RE: PB 320 – 47 Bishop Allen Drive

Attached are the updated plans submitted by the developer as part of the Building Permit Certification of Special Permit conditions. CDD staff is requesting that the Planning Board review and approve the plans dated 8/29/17 at the September 5, 2017 public meeting during General Business.

Date: 08/29/2017 **47 BISHOP ALLEN DRIVE**

### AFTER: (as submitted for building permit August 2017)

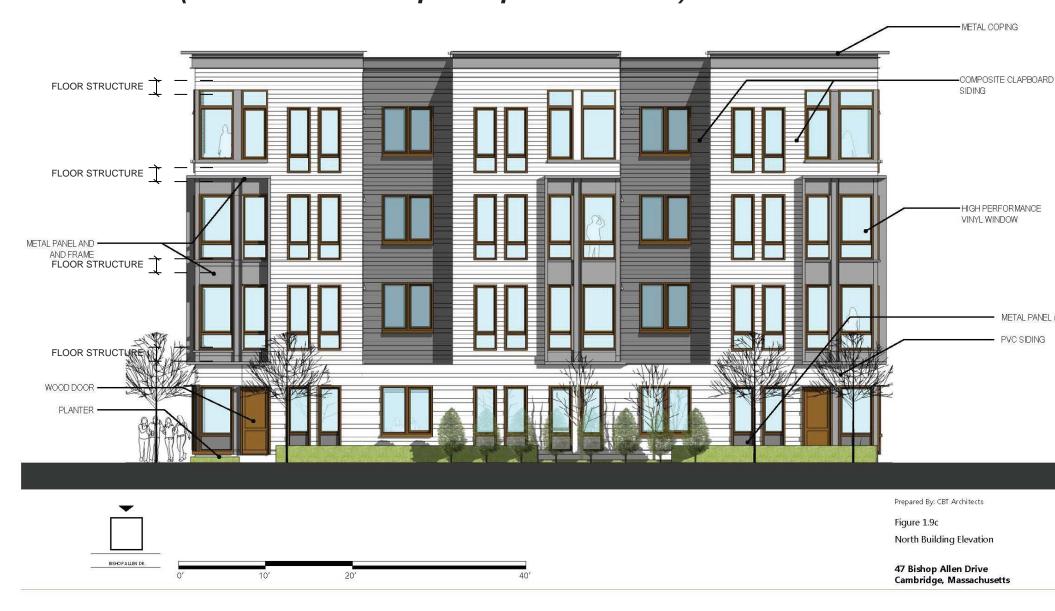
**NOTE:** 4th floor corner unit's top windows shown in living space not possible due to 45' building height and roof/ceiling thickness of assembly

- -No entry doors to units and patios facing Bishop Allen Drive. A green buffer provided to enhance privacy and better define public/private edge.
- -First floor slab raised slightly to further provide privacy to units facing the street and meet DPW 2030 flood elevation requirement at 19.50 CCB.
- -Combined two narrow windows units into one larger unit but w/custom thicker center mullion for ease of construction and detailing given Energy Star's requirement of continuous rigid insulation.
- -Substitute better performance clad wood window for vinyl window.
- -Entry vestibule and doors adjusted to work with entry sloped surface and updated program at ground floor

EAST FACADE ELEVATION

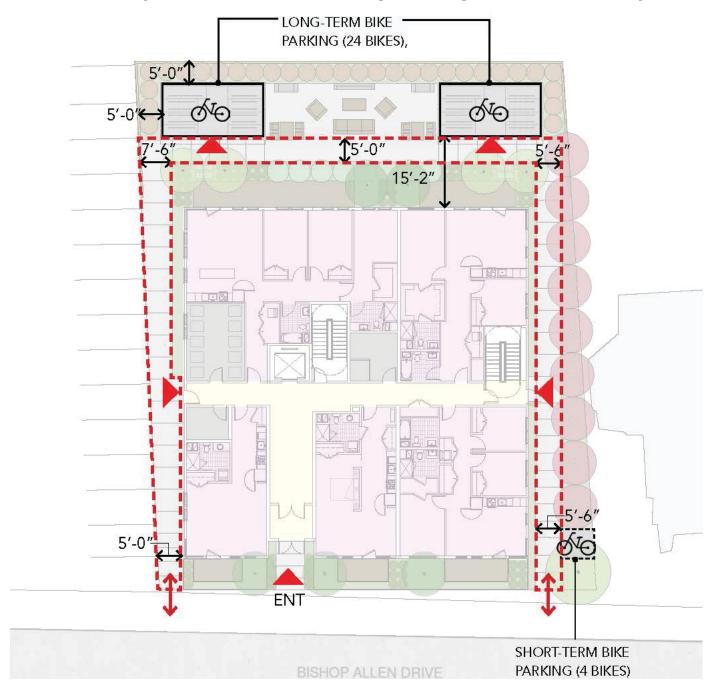
**NOTE:** 4th floor corner unit's top windows shown in living space not possible due to 45' building height and roof/ceiling thickness of assembly

- -No entry doors to units and patios facing Bishop Allen Drive. A green buffer provided to enhance privacy and better define public/private edge.
- -First floor slab raised slightly to further provide privacy to units facing the street and meet DPW 2030 flood elevation requirement at 19.50 CCB.
- -Combined two narrow windows units into one larger unit but w/custom thicker center mullion for ease of construction and detailing given Energy Star's requirement of continuous rigid insulation.
- -Substitute better performance clad wood window for vinyl window.
- -Entry vestibule and doors adjusted to work with entry sloped surface and updated program at ground floor

### AFTER: (as submitted for building permit August 2017)

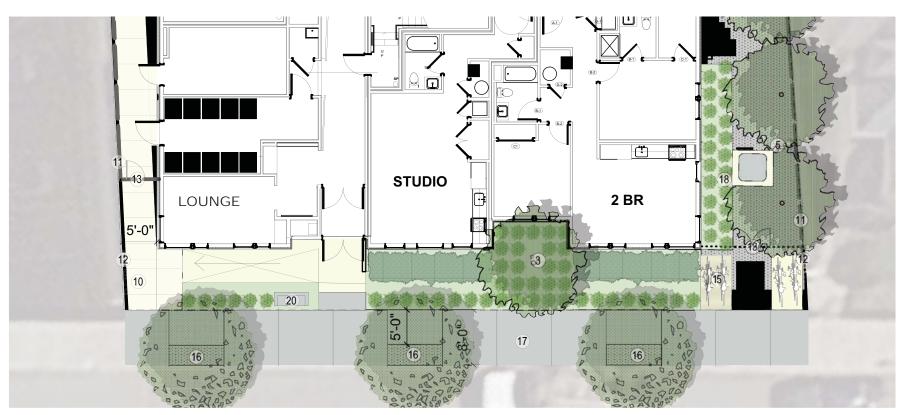
- -New ramp provide to provide compliant access to raised first floor slab.
- -No entry doors to units and patios facing Bishop Allen Drive. A green buffer provided to enhance privacy and better define public/private edge.
- -No paved access on east side to comply with city's green side yard requirement.
- -A transformer (if needed) is placed behind fencing in east side yard.
- -Temporary bike parking at corner to minimize view from Unit windows (at most private wall)
- -3 new street trees at sidewalk
